## Drawing Title: Proposed South East Elevation

OD Camden Hotel Ltd

Project Ref: Orig: Zone: Lev: Type: Role: Num: Rev: HHCAM -PWA-00 - ZZ - DR-A - 0220 - G4 Stage: Scale @ A3: 4 1:200 Status: PLANNING

Haverstock Hill, Camden

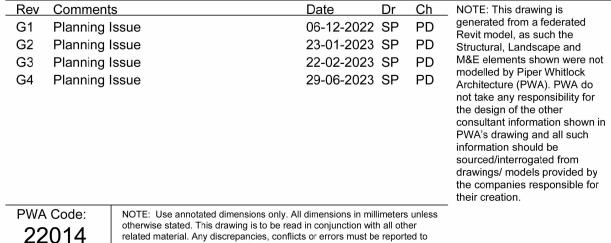
- 1. Balcony set back from curved windows which allows clear views in and out, unobscured by balcony railings.
- 2. Balcony width increased to improve the amenity and outlook.
- 3. Balcony and window arrangement amended to match the architectural language at the corner on Adelaide Road. Balcony improved, corner balcony post removed, enhanced internal apartment space to the corner. Windows added to 5th and 6th floor to provide access to the balcony and allow light into the space. Ground floor window moved around the corner for more privacy.
